| Service Note    |                       |                  |
| Product         | Description:          | Service note no. |
| <b>SDI card</b> | <b>Resistor added</b> | <b>SNo-T0113</b> |

Mounted like this

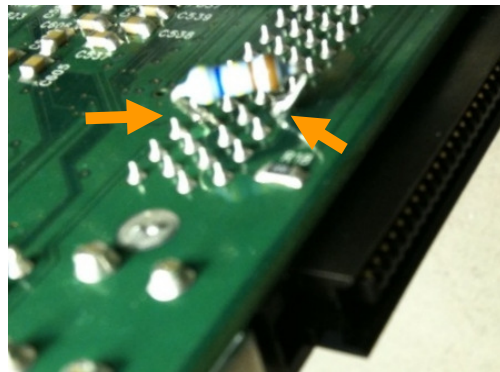
Some of the SDI cards (HW version 203 – identified by visible Firewire connector on the backplate) have been shipped without the resistor by a mistake. See the picture. If the resistor is missing there is a risk that the DB4/8 frame will see the SDI card as an AES card.

All stock should be checked and the resistor should be mounted if missing. The resistor is a 4700 ohm ¼ Watt.

The resistor shall be mounted if missing. The resistor is a 4700 ohm ¼ Watt.
